## Technical Service Bulletin

SUBJECT: REMEDIAL PROCEDURE TO ADDRESS FLASH ARRESTOR

BULLETIN NO.: TSB 2019-01

AFFECTED MODEL(S): **BR-22 PLUS** EXOTHERMIC CUTTING TORCH

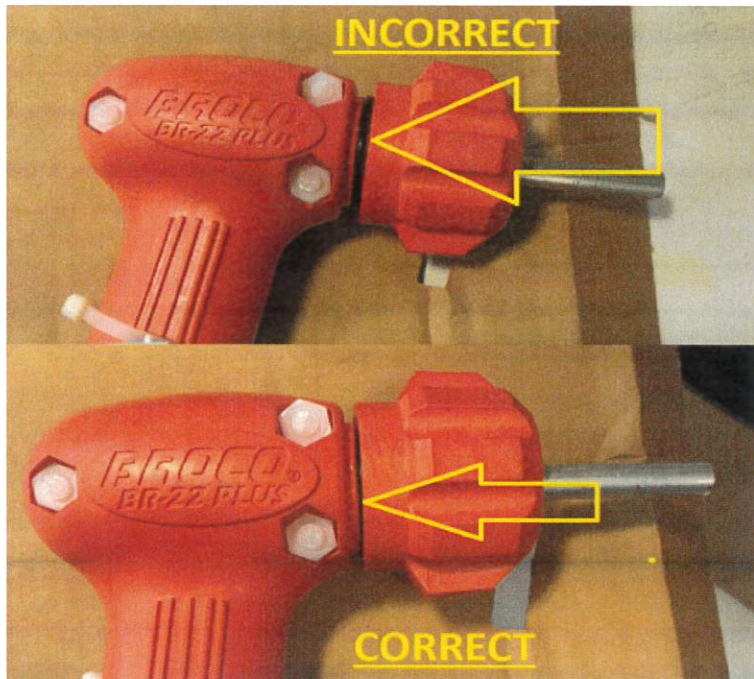
- The pictures below show the correct and incorrect collet nut tightened as it should be. Always use the aluminum test plug (or Broco cutting rod) provided with the torch when tightening to prevent deformation of the collet.

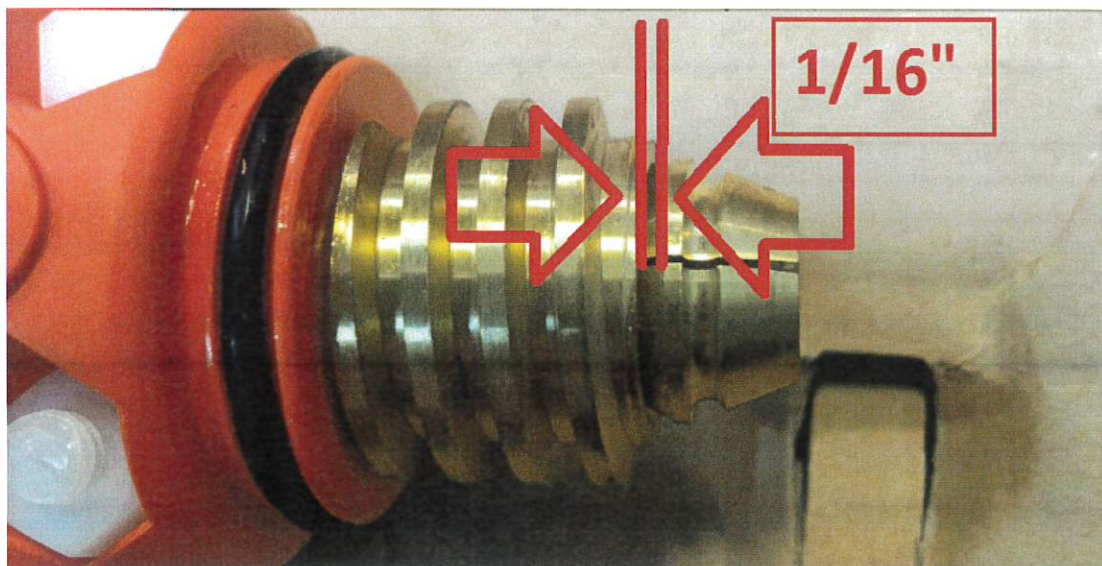
- Check for correct collet seating.

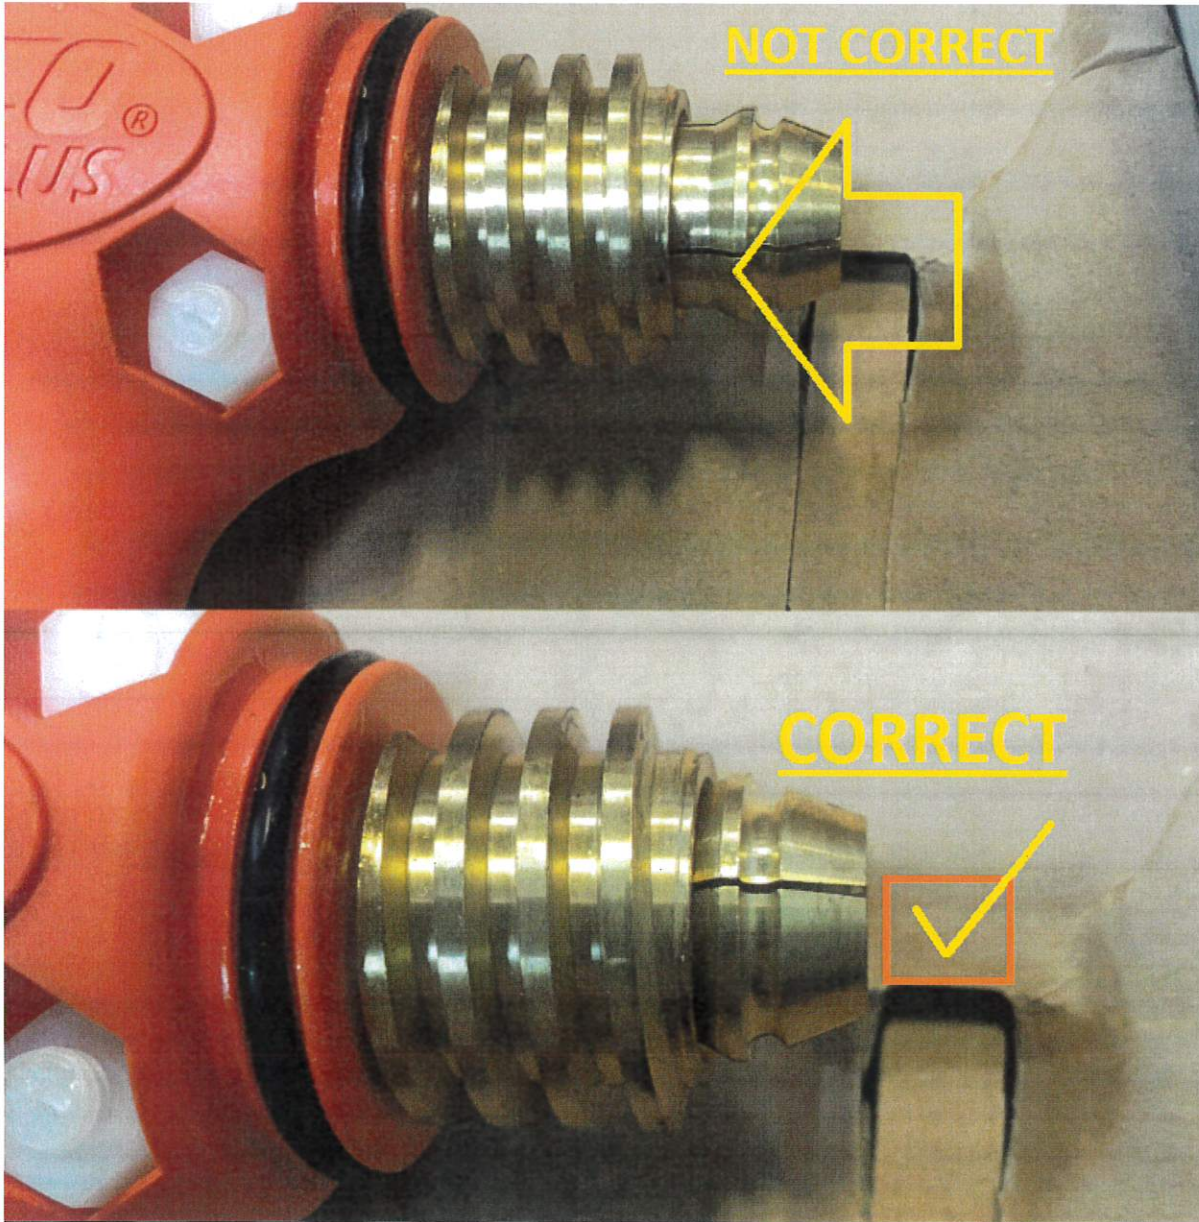
- The collet should be fully seated to the bottom of the collet flange, approximately 1/16 of an inch above the top of the torch head.

- If the collet is too high, remove the collet nut, the collet and the collet washer. Using the 5/32" hex key provided, remove the flash arrestor.

- Replace the flash arrestor with a new flash arrestor and tighten. Do not over tighten as this can strip the hex head.
- Replace the collet washer and the collet pressing down until fully seated as shown above.
- Screw the collet nut on, insert the aluminum plug and tighten to ensure proper closure of the collet nut to the black O-ring.
- Always pressure test the torch before each use and flush it with fresh water after each use.
